**SUBJECT:** Calvert Cliffs Nuclear Power Plant  
Unit No. 1; Docket No. 50-317  
Response to Request for Additional Information Regarding Interim Inspection  
Requirements for Reactor Pressure Vessel Head (TAC No. MC1921)

**RESPONSE TO NRC REQUEST FOR ADDITIONAL INFORMATION**

#### RELAXATION REQUEST 1

0° (Central) CEDM Nozzle Hoop Stress

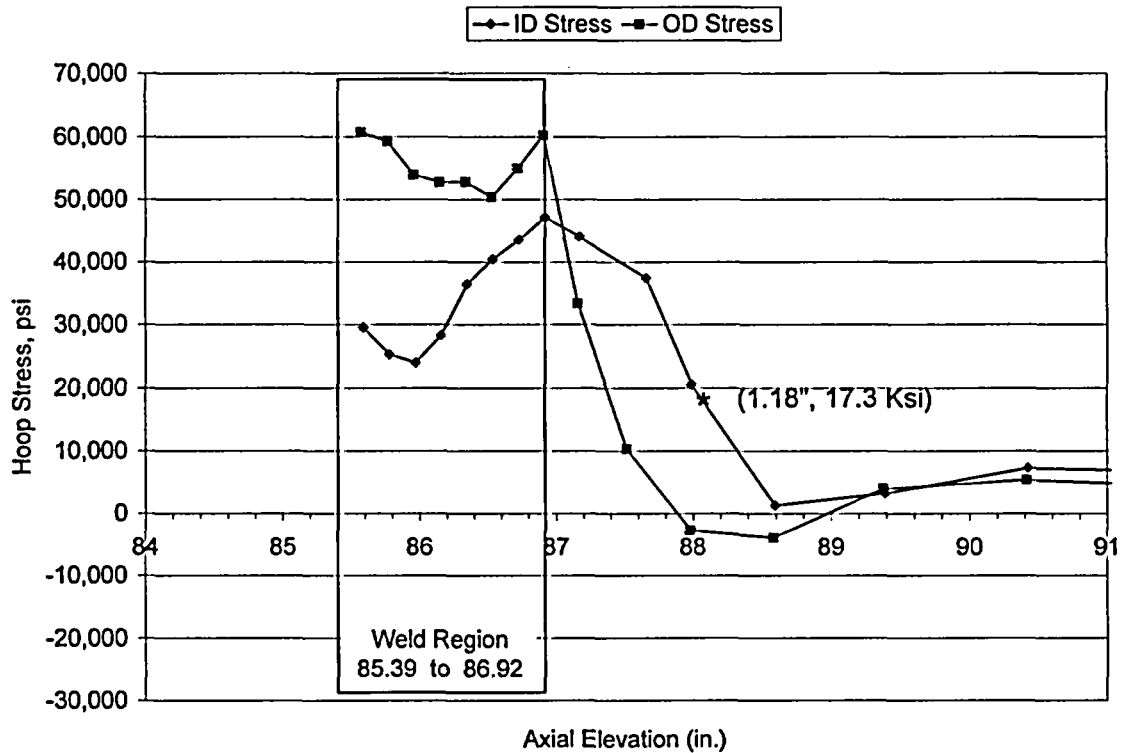
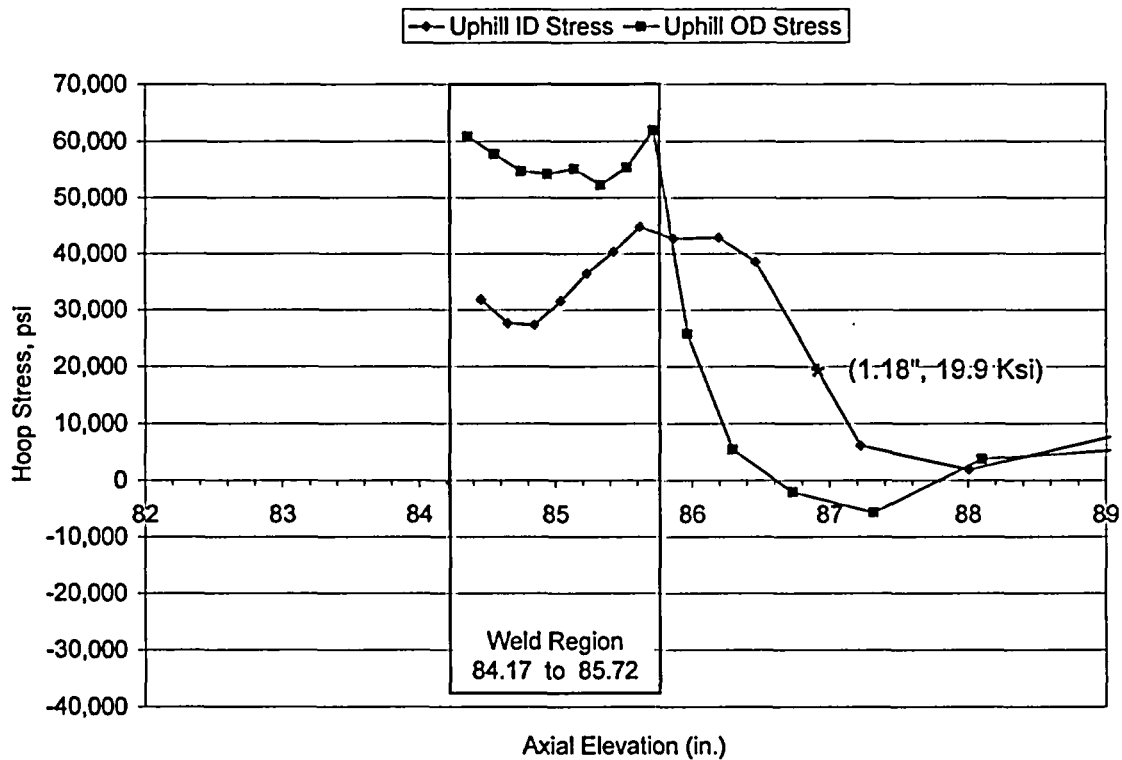
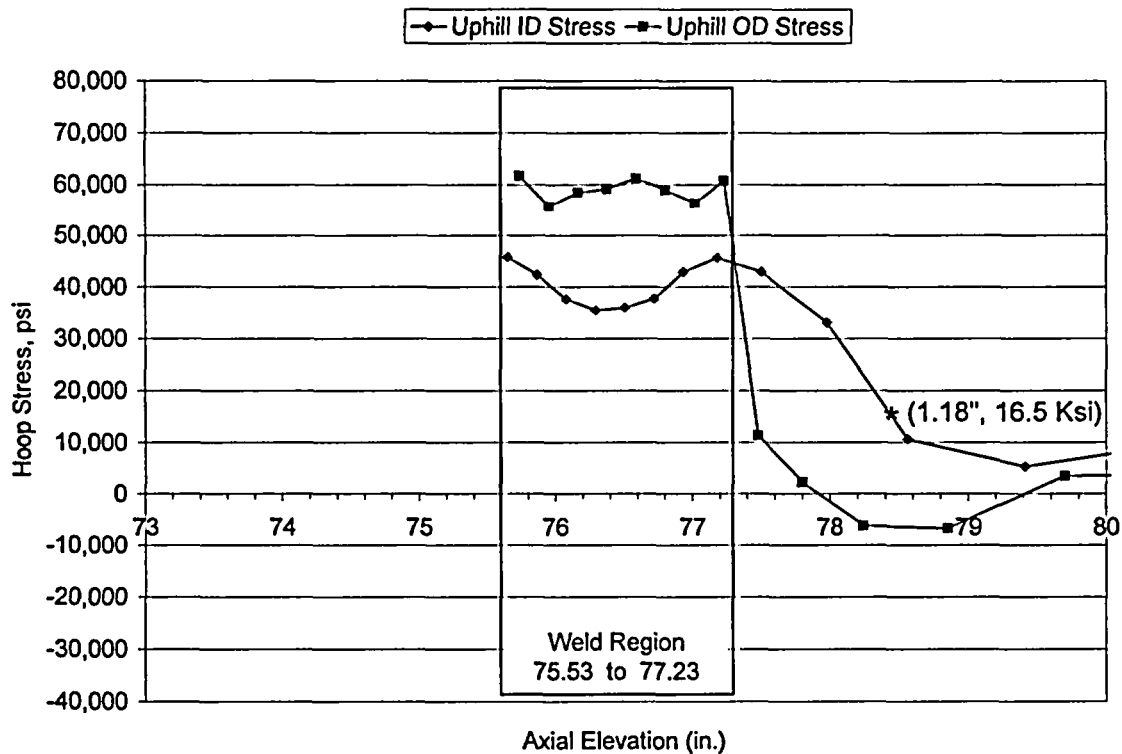
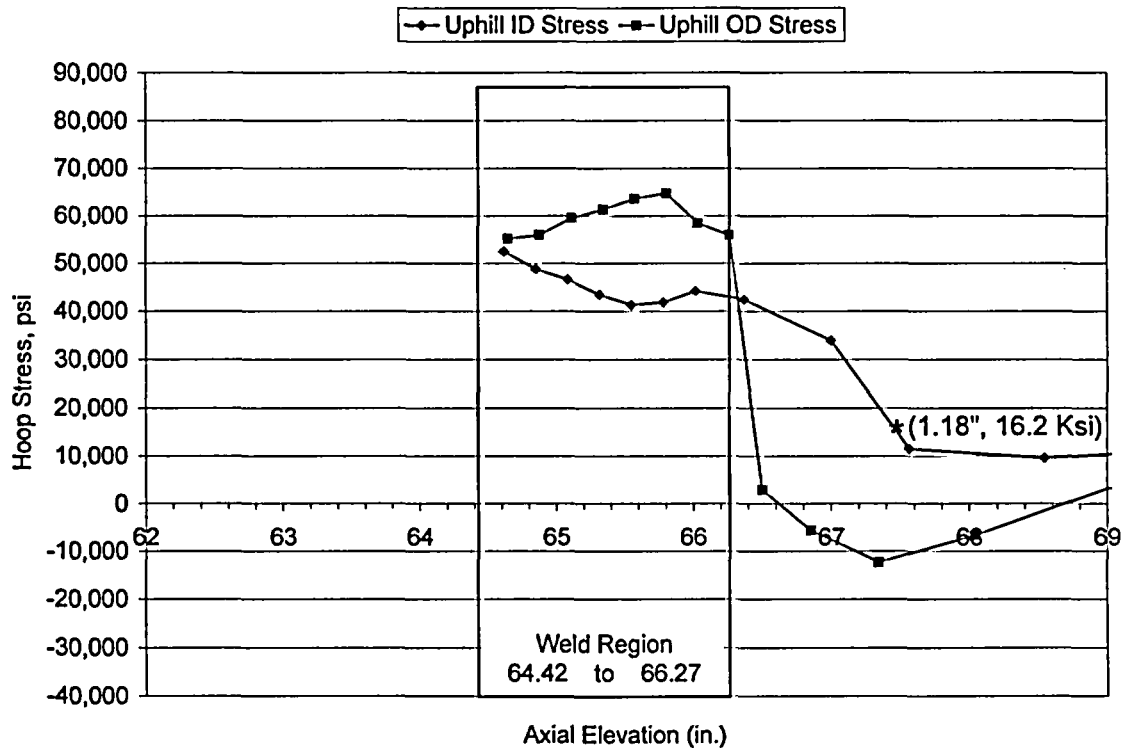
*Please provide justification that coverage up to 0.75 inches above the weld will provide an adequate level of quality and safety. Are there residual stress data for Unit 1 that indicates that 0.75 inches is a sufficient level above the weld, or is there any other basis that demonstrates an acceptable level of quality and safety for the restricted inspections?*

We have performed a residual stress analysis of the CEDM nozzles. For all of the penetrations, the highest, bounding, residual stress on the ID surfaces at 1.18 inches above the highest point of the root of the J-groove welds is 19.9 ksi. The stresses were calculated for all downhill, sidehill, and uphill locations at all elevations on all nozzle configurations. The peak residual stress on the ID at 1.18 inches above the highest point of the root of the J-groove weld of 19.9 ksi occurs on the uphill side of the 11 degree nozzle. Peak stress values on all nozzle configurations are:

Residual stress profiles are shown in the following plots:

On the OD, both hoop and axial stresses at 0.75 inches above the highest point of the root of the J-groove weld are below 7 ksi in all cases.

As indicated in Materials Reliability Program (MRP)-95 (Reference 2), 20 ksi is a reasonable stress threshold below which primary water stress corrosion cracking (PWSCC) is not expected to occur. Additionally, the yield strength of the Calvert Cliffs material is 42 ksi. The highest residual stresses at the 1.18 inch elevation are less than 48% of the yield strength. As indicated in Reference 2, PWSCC has not been observed in material subjected to stresses lower than yield. Therefore, PWSCC is not expected to initiate in the region for which relaxation is requested.

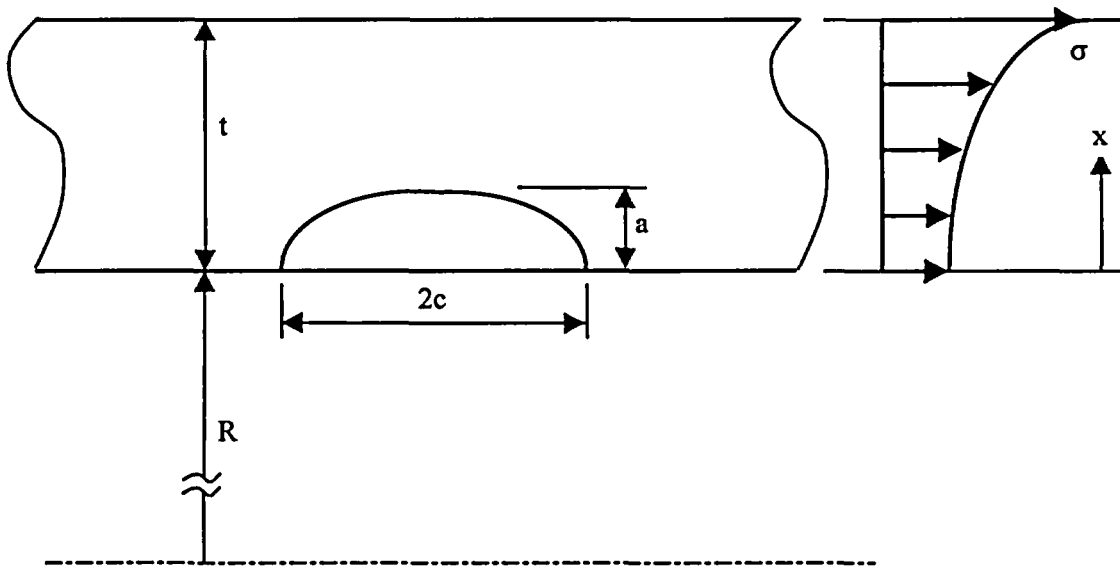
*Did the licensee perform a crack growth evaluation above the weld? If so, what was the initial flaw size and was it through-wall? The licensee is requested to describe the methodology in detail, [emphasis is the original] and provide examples for the crack growth calculations. Did the licensee perform this evaluation in accordance with the MRP-55 guidelines? Did the licensee perform the evaluation, or was it performed by a contractor? Was the crack growth evaluation based on the as-built weld geometry? Please provide justification if the crack growth evaluation was not based on the as-built weld geometry.*

The results of the residual stress analyses indicate stresses decrease rapidly with distance above the J-groove weld. We performed a crack growth rate calculation for a hypothetical crack having a 6:1 aspect ratio and spanning the distance between the elevation we are seeking relaxation for (1.18 inches on the ID) and the elevation required by the order (2 inches). We evaluated a 0.82 inch long, ID surface connected, 6:1 aspect ratio crack. We performed crack growth calculations for two different locations. For the first calculation, the lower end of the crack was 1.18 inches above the root of the J-groove weld. For the second calculation, the lower end of the flaw was placed at an elevation 2 inches above the root of the J-groove weld. The results indicate there is little difference in crack growth for flaws located 1.2 inches above the weld or greater than 2 inches above the weld.

As indicated in our response to NRC Request 2, we have performed crack growth calculations. The methods and results are discussed in the response to NRC Request 2. The calculation was performed in accordance with MRP-55 guidelines. We contracted to Dominion Engineering and AREVA (formerly Framatome-ANP) for the stress analyses and fracture mechanics analyses. A parametric study was performed to determine the effects of as-built weld size below the weld on the residual stresses in the nozzle. The analysis indicated there was little effect of the as-built weld geometry on the stresses above the weld, particularly on the high hillside portion of the nozzle above the weld. The parametric study indicated that it was not necessary to consider the as-built weld geometry during a crack growth analysis above the weld.

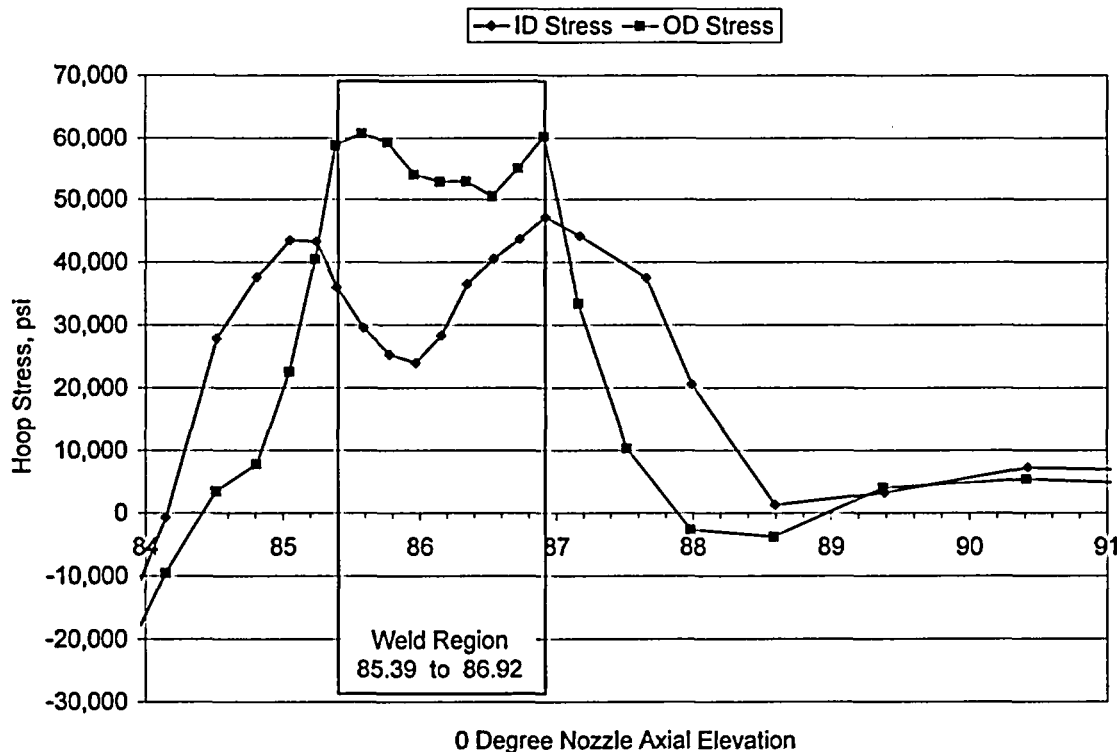
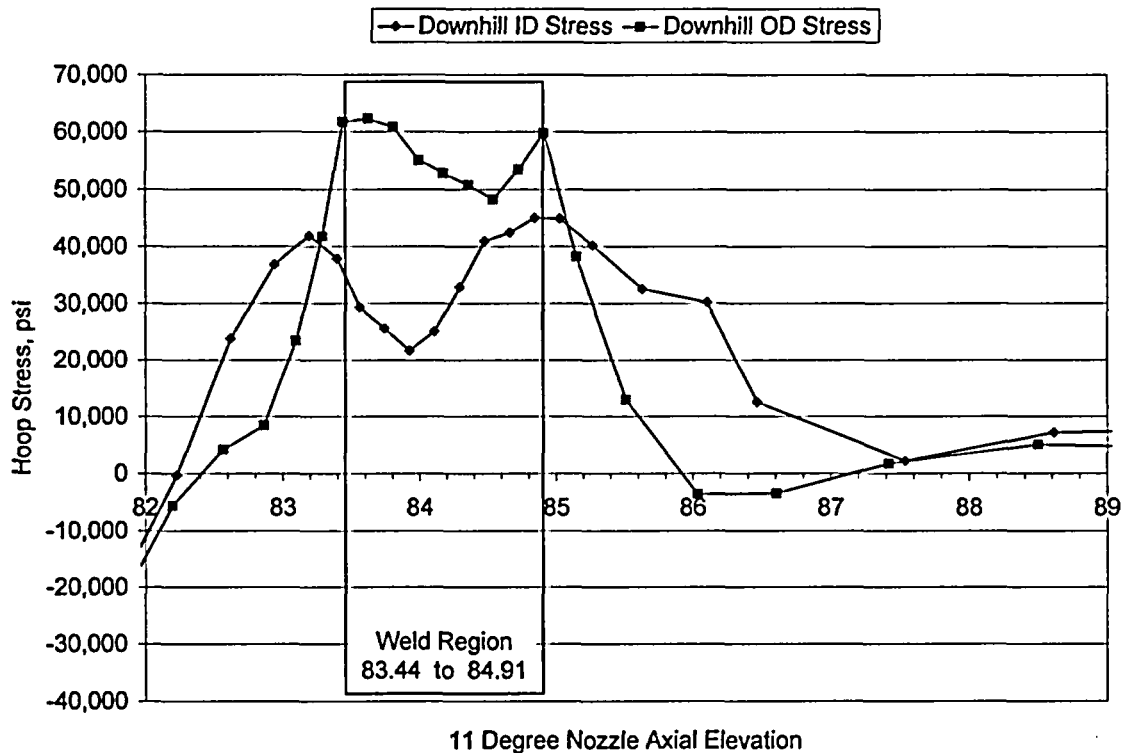
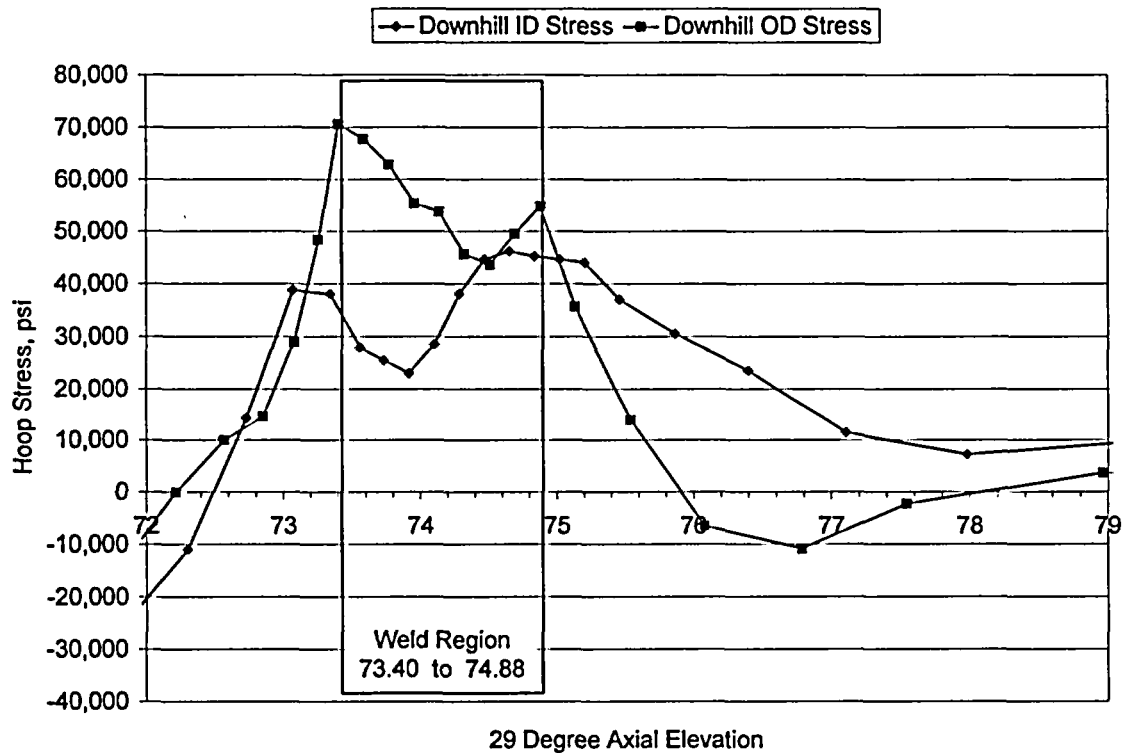
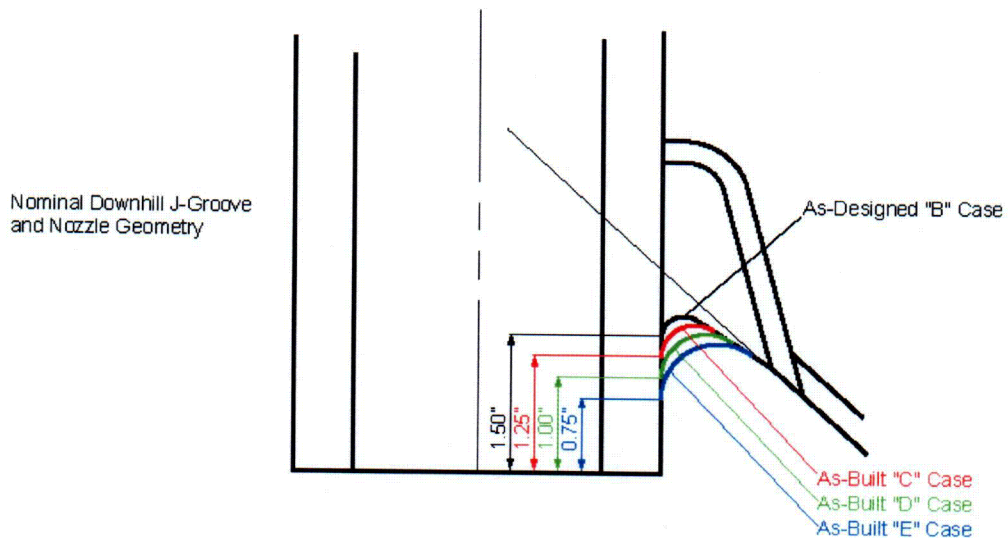
*What is the maximum hoop stress in the bottom portion of the nozzle? Please provide crack growth predictions for through-wall axial flaws located at various angles in the CEDM's.*

We performed plant specific stress analysis for all of the CEDM nozzle groups. For the 43° angle nozzle below the weld we assumed four different fillet weld sizes to represent various cases of as-built conditions. The stress analysis results depend on fillet weld size, on nozzle angle, and vary around the circumference of the nozzle.

This table shows that the lowest elevation in the 0 degree nozzle that experiences a hoop stress of 20 ksi or above is 1.0 inch below the toe of the weld on the ID, uniformly around the circumference. The following plot shows the results graphically.

This table shows that the lowest elevation in the 11 degree nozzle that experiences a hoop stress of 20 ksi or above is 0.9 inches below the toe of the weld on the downhill portion of the weld. Note that the hoop stresses at the sidehill and uphill azimuths at the same elevation are far less than 20 ksi. The following plot shows the results graphically.

This table shows that the lowest elevation in the 29 degree nozzle that experiences a hoop stress of 20 ksi or above is 0.6 inches below the toe of the weld on the downhill portion of the weld. Note that the hoop stresses at the sidehill and uphill azimuths at the same elevation are far less than 20 ksi. The following plot shows the results graphically.

This table shows that the lowest elevation in the 43 degree nozzle that experiences a hoop stress of 20 ksi or above is 0.5 inches below the toe of the weld on the downhill portion of the weld. Note that the hoop stresses at the sidehill and uphill azimuths at the same elevation are far less than 20 ksi. The 43 degree nozzle was also modeled with several different assumptions about the as-built weld geometry. The following illustration shows the variety of as-built geometries that were modeled.
